PHASE 1

PHASE 2

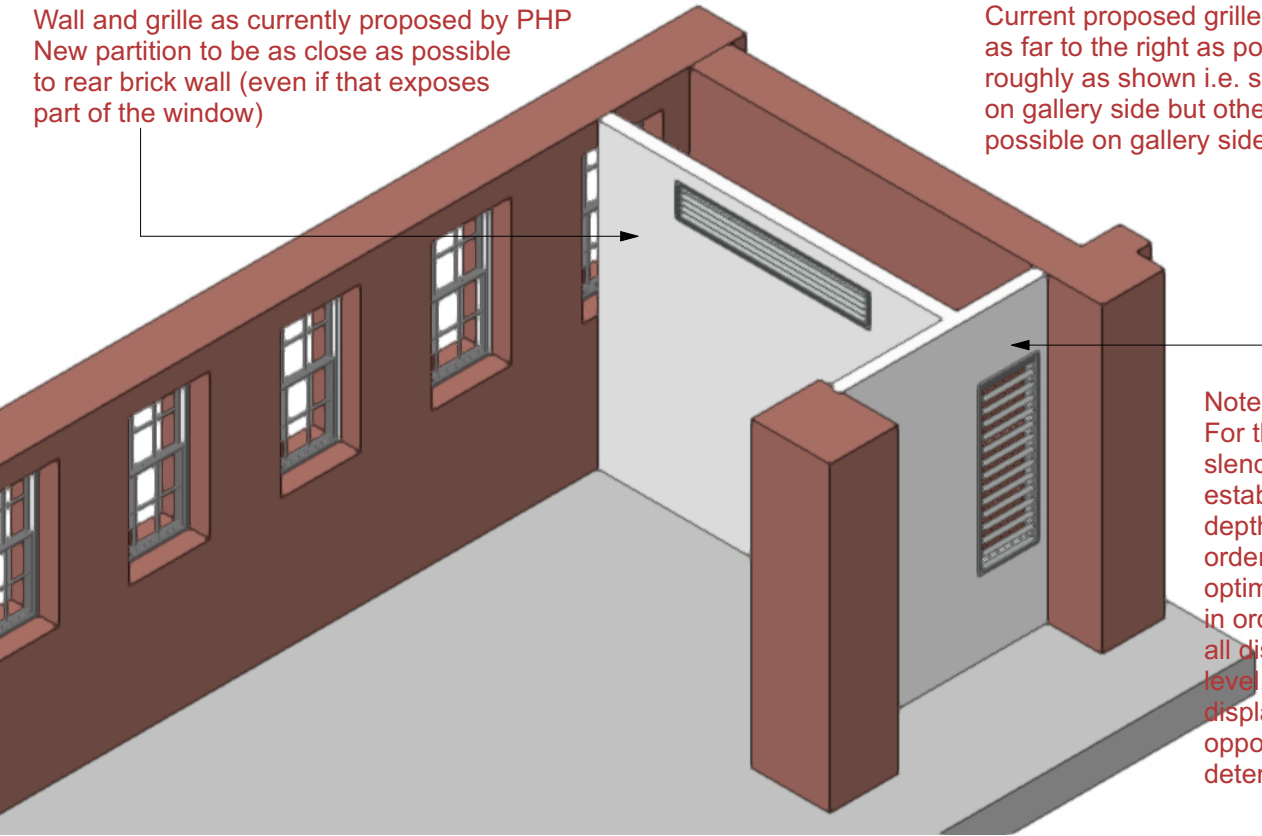
Wall and grille as currently proposed by PHP
New partition to be as close as possible to rear brick wall (even if that exposes part of the window)

Current proposed grille pushed (if possible) as far to the right as possible. Wall positioned roughly as shown i.e. small reveal to brick pillar on gallery side but otherwise set back as far as possible on gallery side

Note:
For the proposed Phase 2 slender grille, we need to establish its minimum depth from the ceiling in order to determine the optimum wall height because in order to have tops of all display walls at the same level, the height of the long display wall in the gallery opposite the windows will be determined by this dimension

Additional partition built in front of phase one partition (aligned to completely conceal window) with slender recessed grille at top abutting ceiling.

Additional partition built in front of phase one partition (positioned to create reveals to brickwork) with slender recessed grille at RHS abutting brick wall.
